THE SHOPS FILING NO. 2 AT MERIDIAN RANCH LOT 2

SITE DEVELOPMENT PLAN
EL PASO COUNTY, COLORADO.
FALCON, COLORADO

DRAWING NO.
COVER
SITE DEVELOPMENT PLAN

DRAWING NO. 1
SITE DEVELOPMENT PLAN

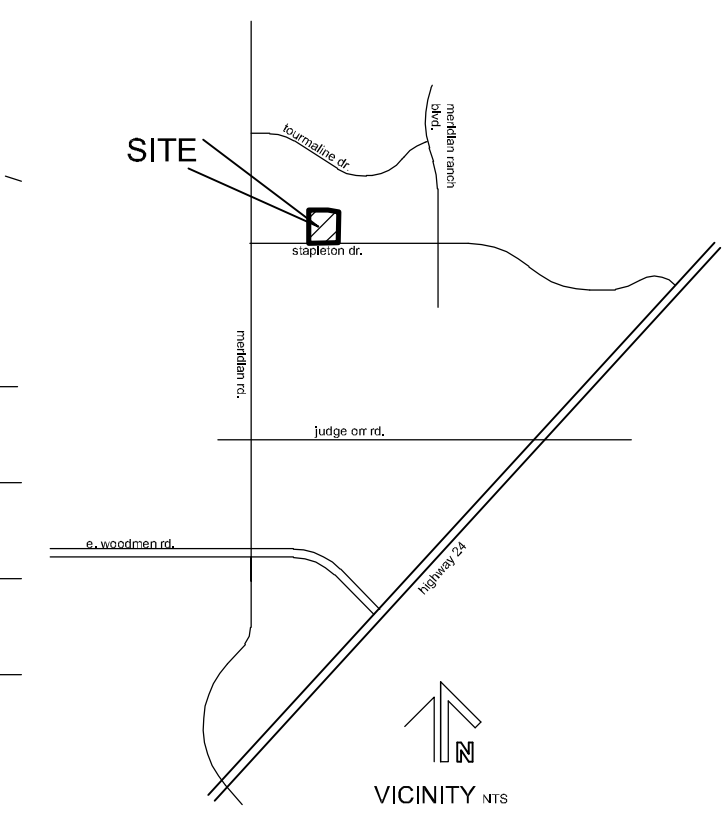
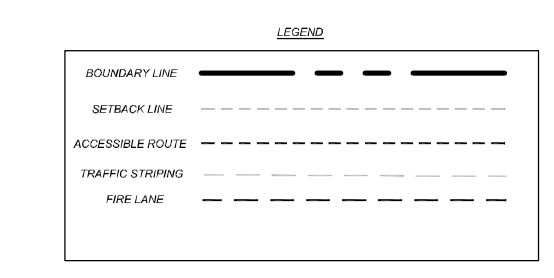
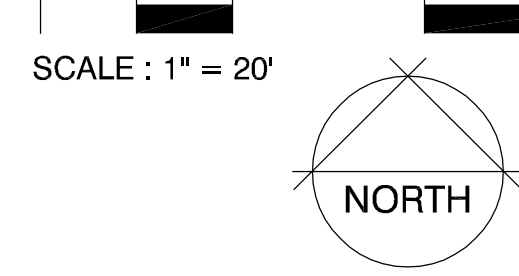
Previous comment not addressed. Parking spaces adjacent to curbs appear to be 8 ft. Minimum width is 9 ft. for 90 degree parking spaces

Previous comments had asked for the building information to be updated. Per the 1" = 20' scale, this building is approx. 11,827 sq. ft. Please ensure the measurements are accurate, as this will impact the parking requirements.

Include the previously identified note that the gas canopy has a 25 ft setback.

This calculation still doesn't include the gas canopy which is a structure.

Previous comment not addressed. Update this with the correct square footage calculations and the correct uses, which are GAS STATION and COMMERCIAL CENTER, LESS THAN 10 ACRES.

GAS STATION PARKING CALCS are 1 space per employee on maximum shift, plus 3 spaces per bay or stall IN ADDITION to the 1 space per 250 sq. ft. for the commercial center. You need to identify the max number of employees and the number of gas pumps in order to provide the parking calculation.
